**CITY OF NAPOLEON
BUILDING CONSTRUCTION PERMIT
(1, 2 or 3 Family Dwelling)**

Norman King
840 Strong St.
Napoleon, Ohio
Addendum To Plan Approval

DATE Oct. 24, 1975	JOB NO. Permit No. 419-75
PROJECT New Single Family Dwelling	
LOCATION 427 W. Clinton St.	
CONTRACTOR King	OWNER King
WEATHER _____	TEMP. _____ at _____ AM _____ at _____ PM
PRESENT AT SITE CITY OF NAPOLEON ENGINEERING DEPT. PLAN APPROVAL BY: <u>P.W.</u> DATE: <u>10-24-75</u>

Letter No. 419-75L
FIELD REPORT

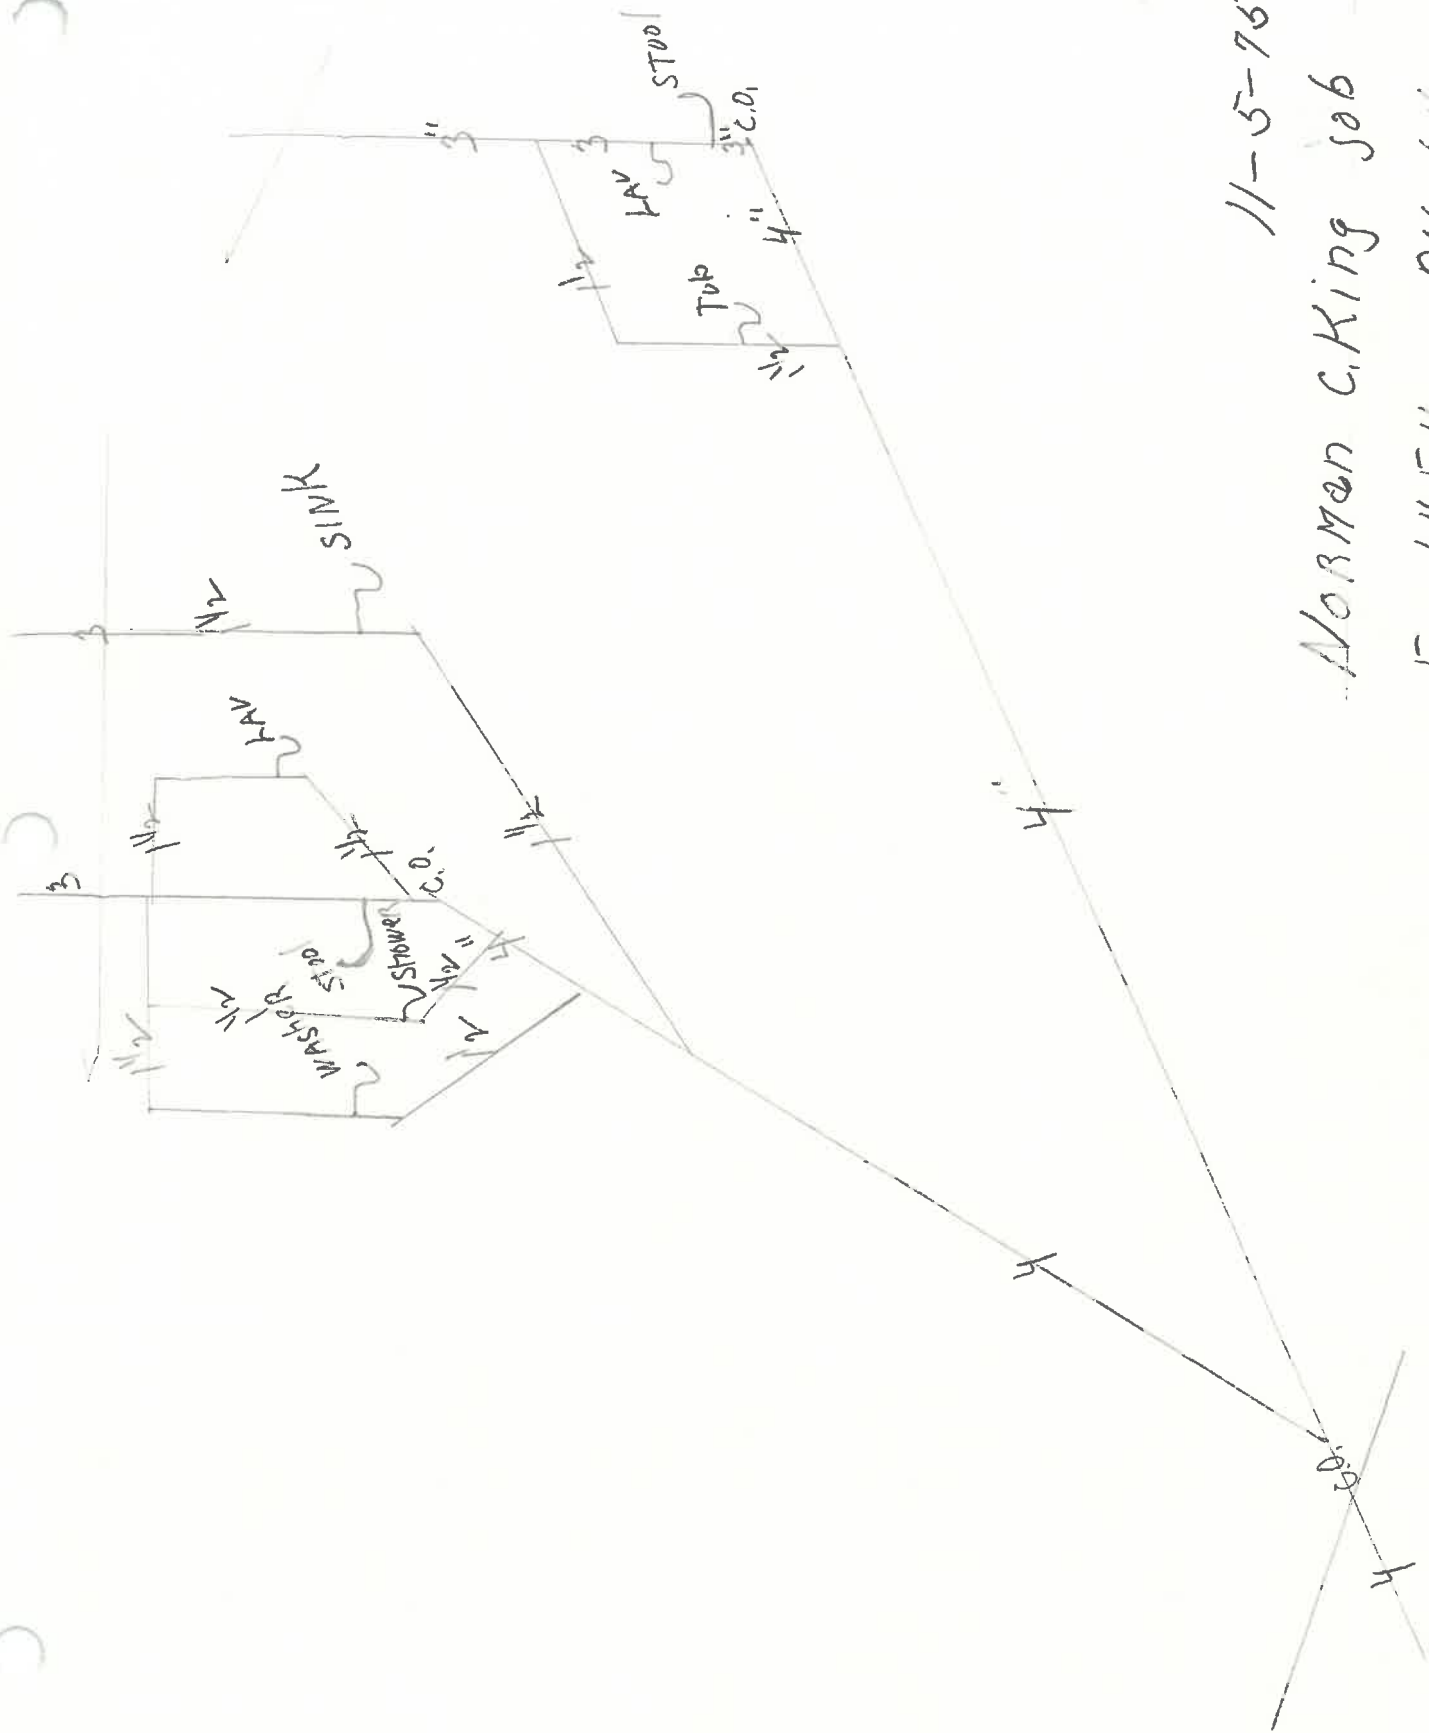
- 1) The water distributing system shall be protected in an approved manner against backflow. Sec. BB-51-38 OFC.
- 2) Provide min. of 4" G.O. within 3' of outside wall. Sec. BB-51-21 OFC.
- 3) Cleanouts shall be installed at each change of direction of the building drain greater than 45 degrees. Sec. BB-51-21 OFC.

Riser Diagram

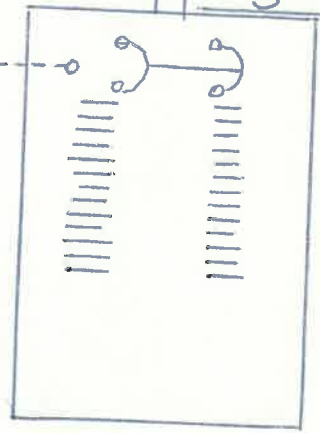
Inadvertently, I approved your service rated at 200A with service conductors of size #2 THW. Conductors for 200 amp service should be #6 in 2" conduit. Please make this correction at your earliest convenience.
